BID #1436: ANIMAL CONTROL FACILITY PROJECT

ADDENDUM NO. 2

DATE: March 4, 2020
TO: All Potential Bidders
FROM: Jason L. Reynolds, PE (County Consultant)
SUBJECT: Addendum No. 2 – Animal Control Facility Project
BID NO.: 1436
BIDS TO BE OPENED: **March 12, 2020, at 10:00 a.m. Central Time (Revised per Item#1)**

REV 1: 2/28/20
 SHEET **A-1**

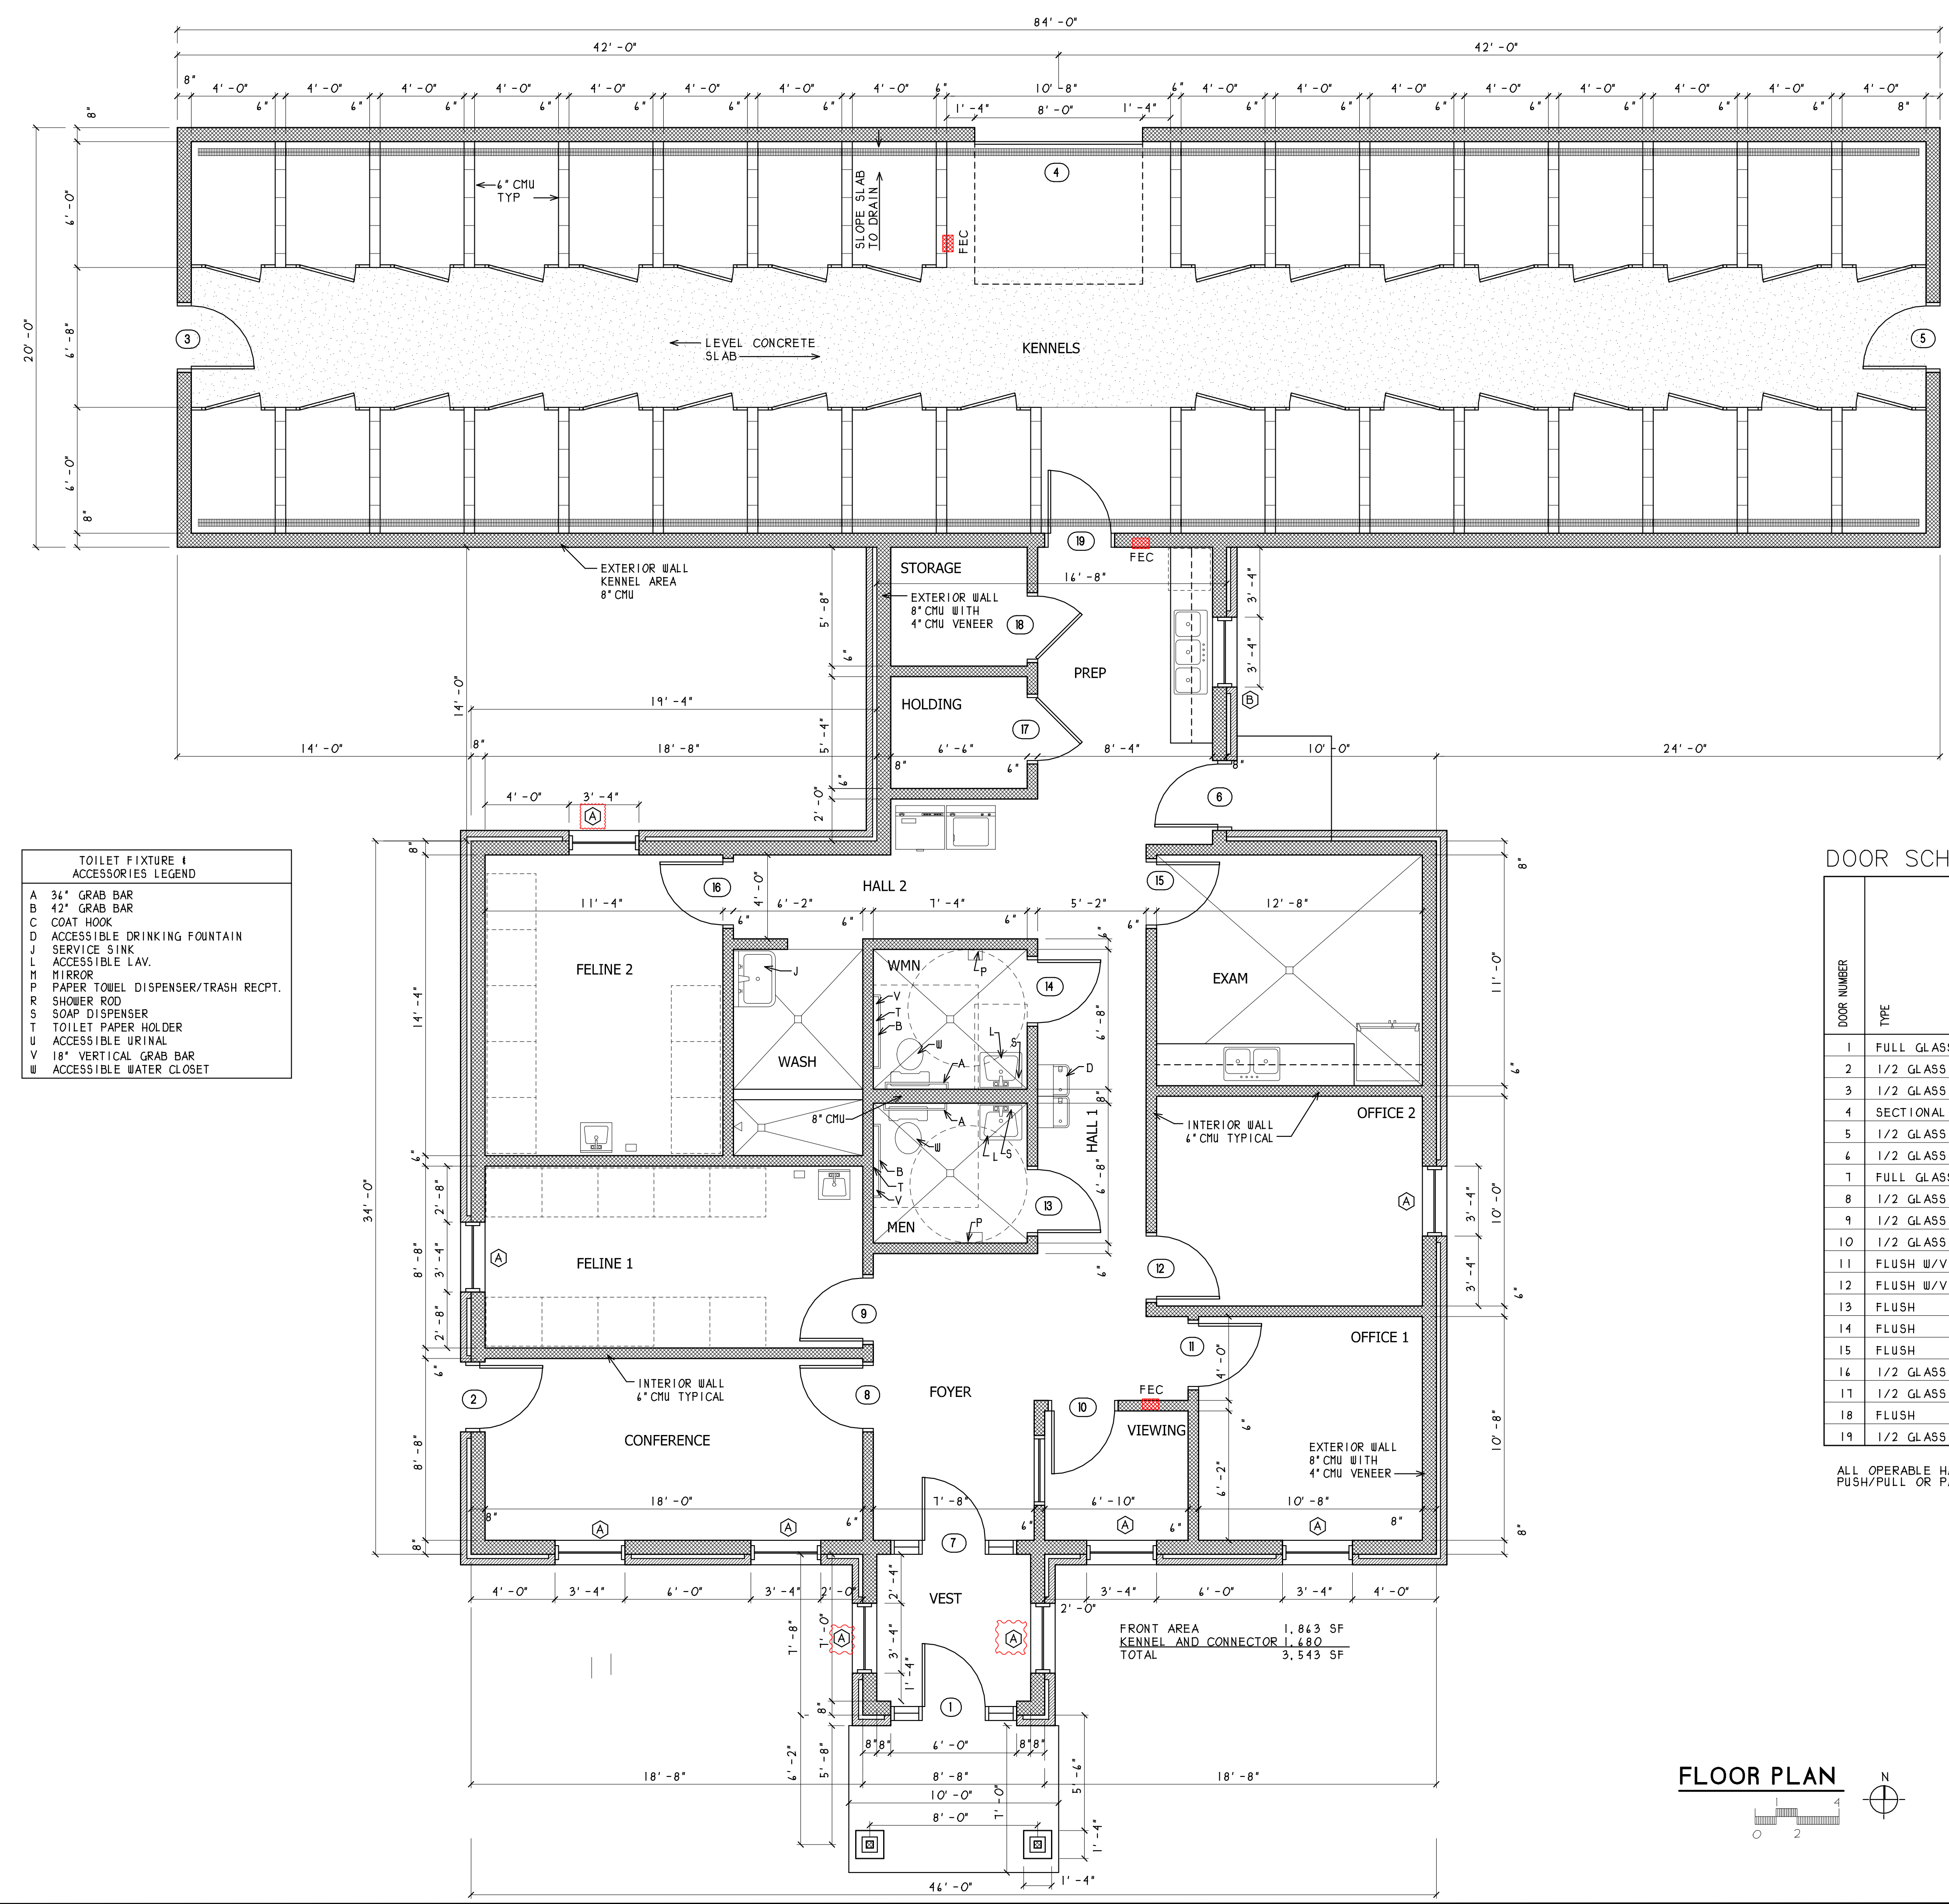
Issue: Sheet A-1 Floor Plan for the Kennel Area calls out the Exterior Wall as 8" CMU but Sheet A-2 Elevations for the Rear Elevation or Kennel Area states 4" split faced CMU. Please clarify.

Issue: Sheet A-1 Window Schedule refers to Type A and Type B windows. Spec Section 08520 1.1 refers to (3) types of windows. Back to sheet A-1: Out of 14 windows shown (4 of them I assume are fixed storefronts at the vestibule) on the floor plan only (6) Type A are labeled and (1) Type B is labeled. Feline 2 has no demarcation for the window and the (2) windows in the vestibule have no demarcations. Please clarify what types of windows you would like these to be and please confirm that the "aluminum fixed windows" listed in the specs are the storefronts on either sides of the doors in the vestibule.

Response: See revised sheets A-1 and A-2 clarifying matching information (no 4" block in the vicinity of the kennel area).

Response: There two types of windows:

A: are the typical windows

B: is in the prep area

The only storefront is at the front wall of the vestibule and dimensioned as 6'-0" wide with the heads at 7'4". Feline 2 and side wall of Vestibule is window A

POWER/SYSTEMS PLAN

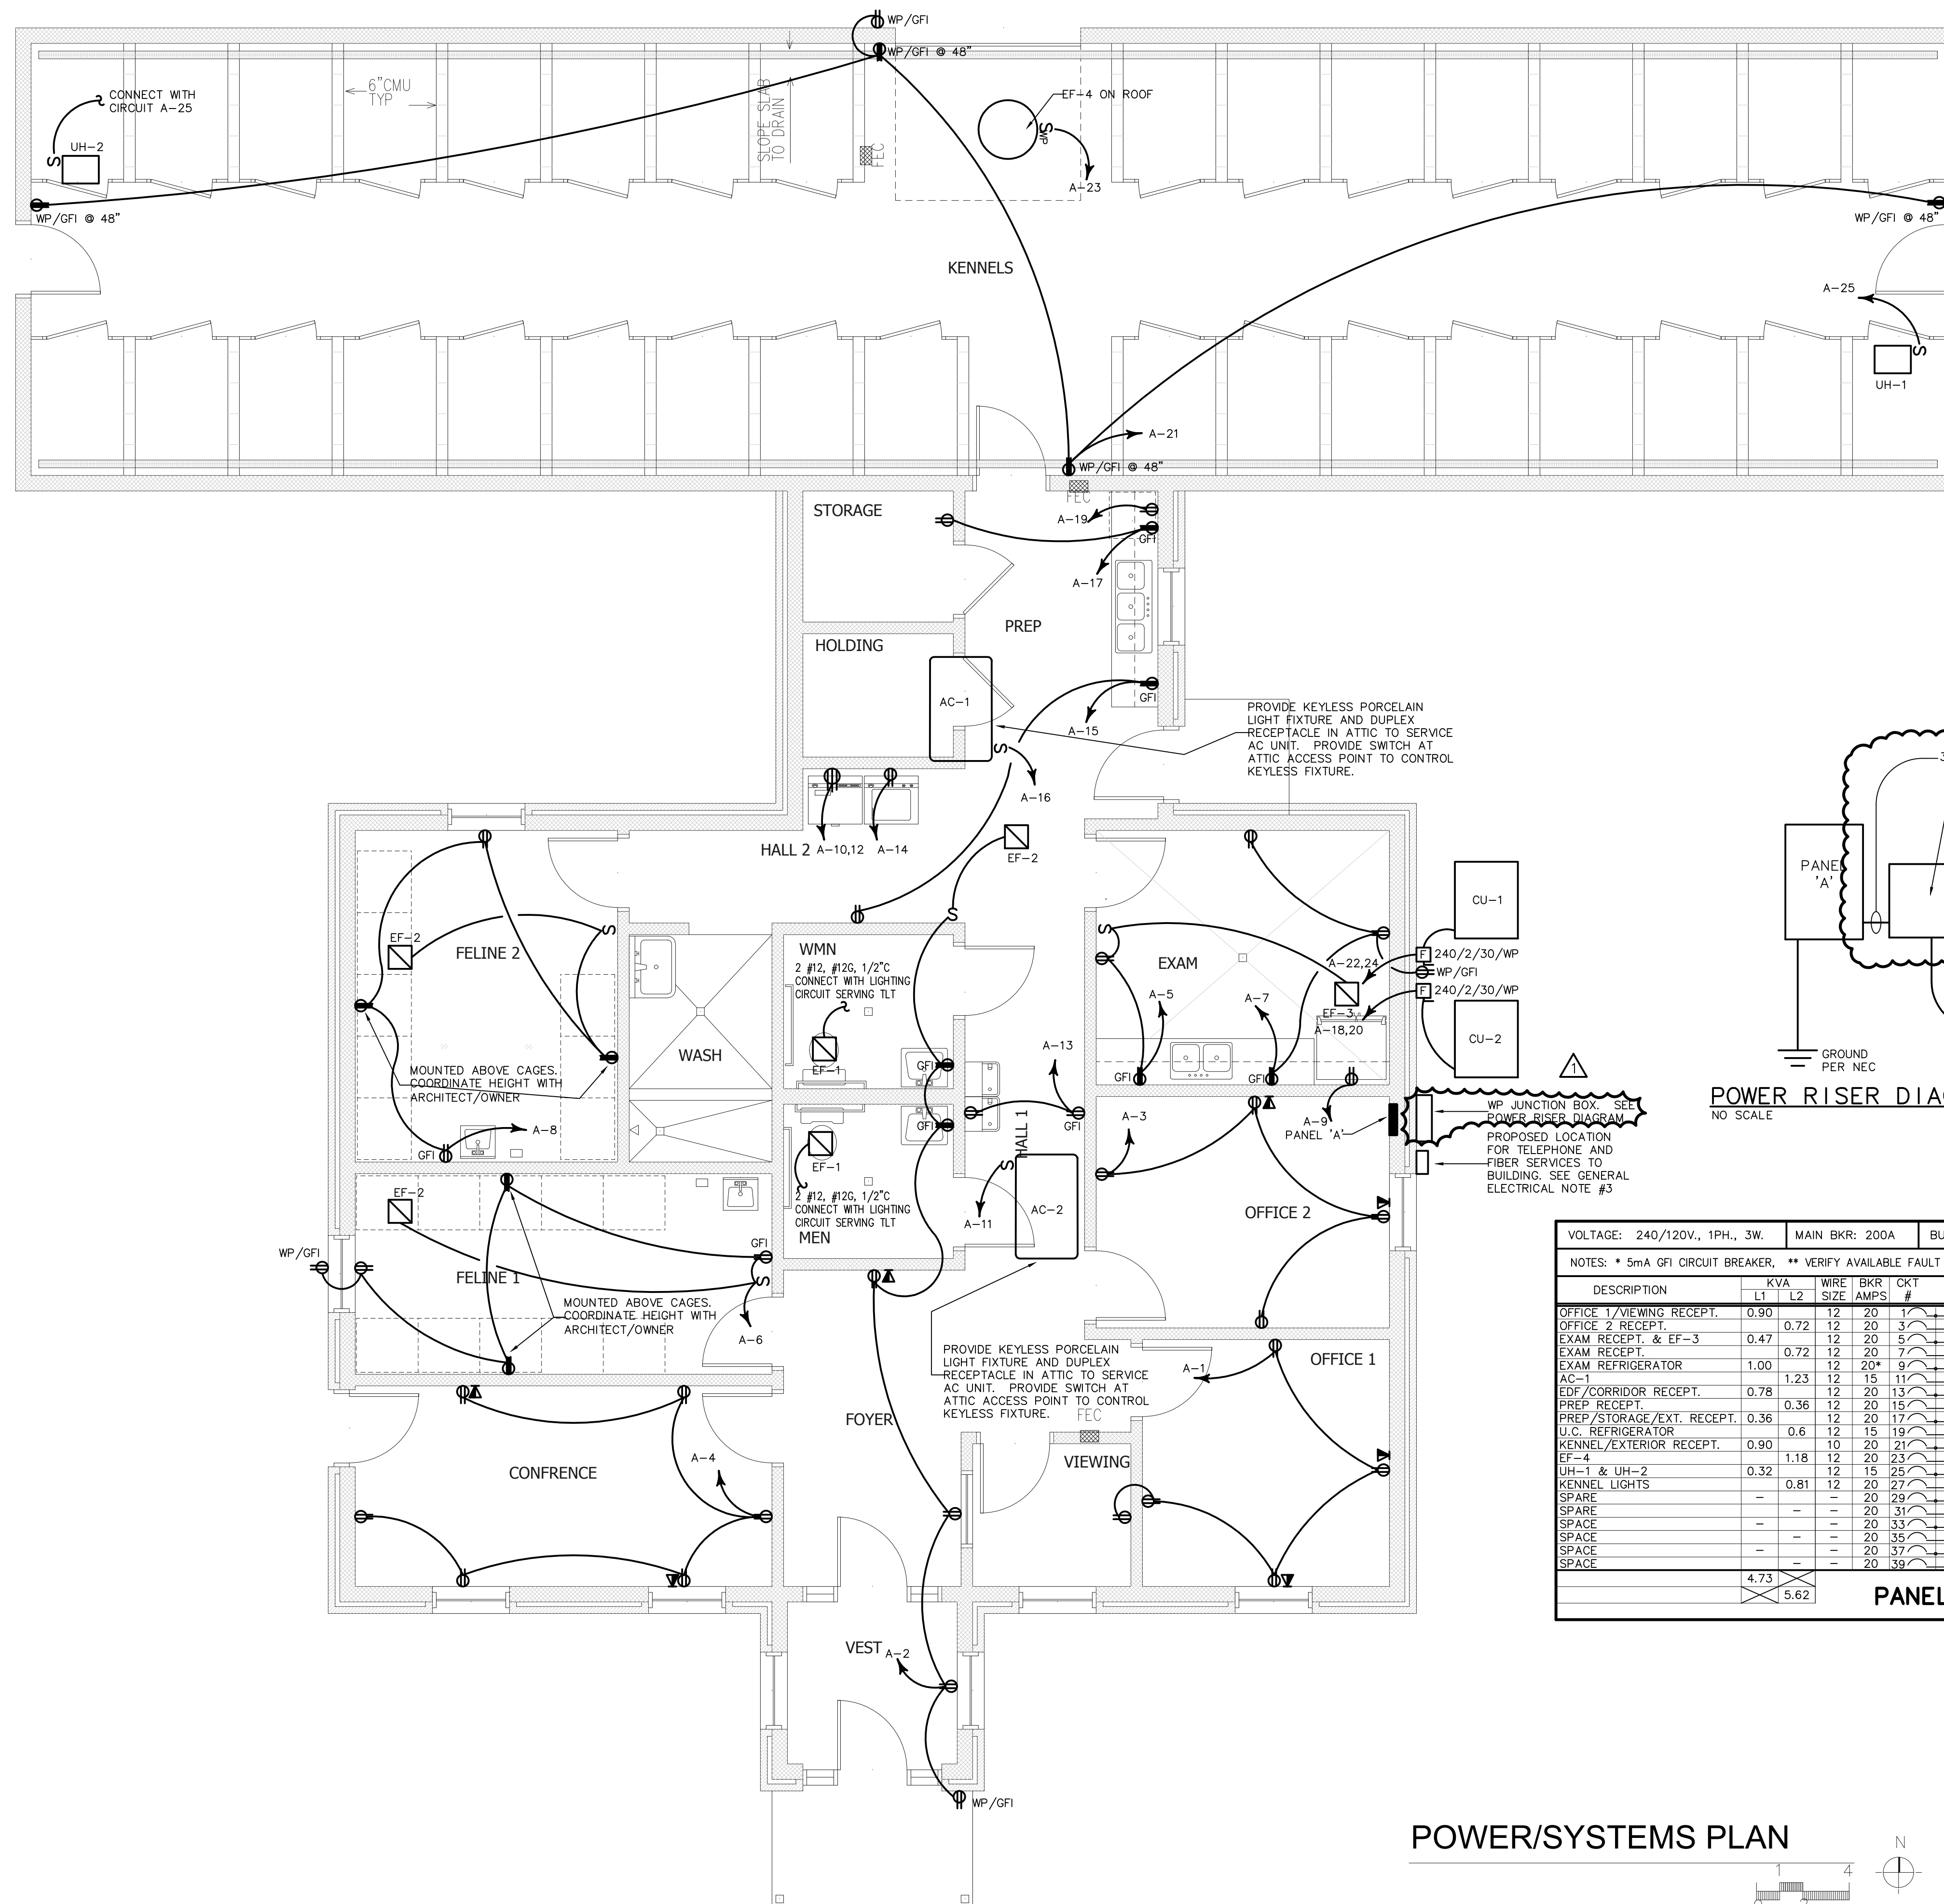
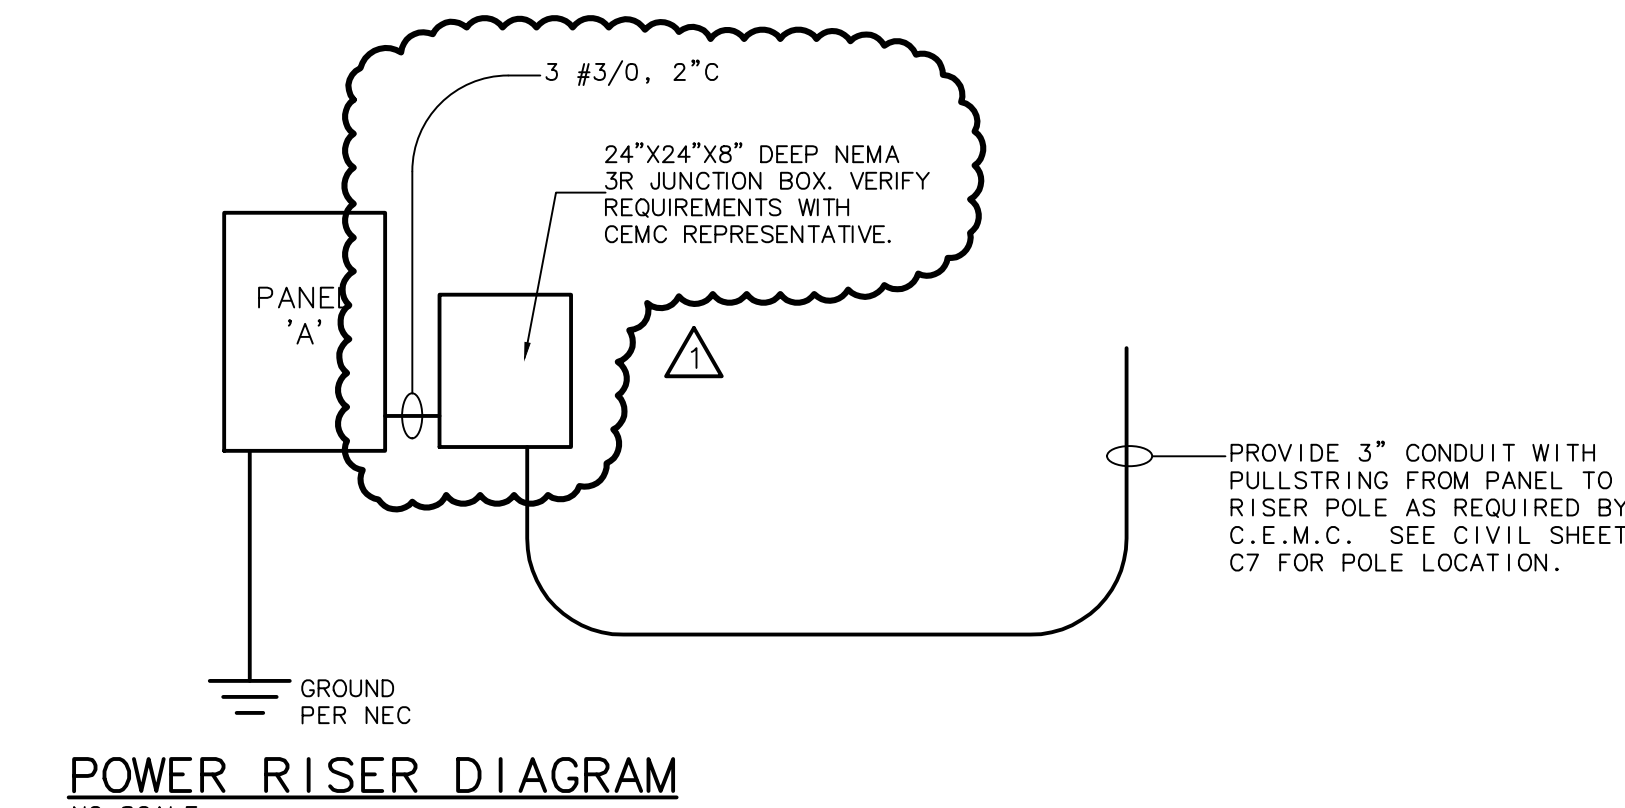
Issue/Question: Clarification on service panel/power diagram.

Response: Please see that attached revised electrical drawing sheet E-2.
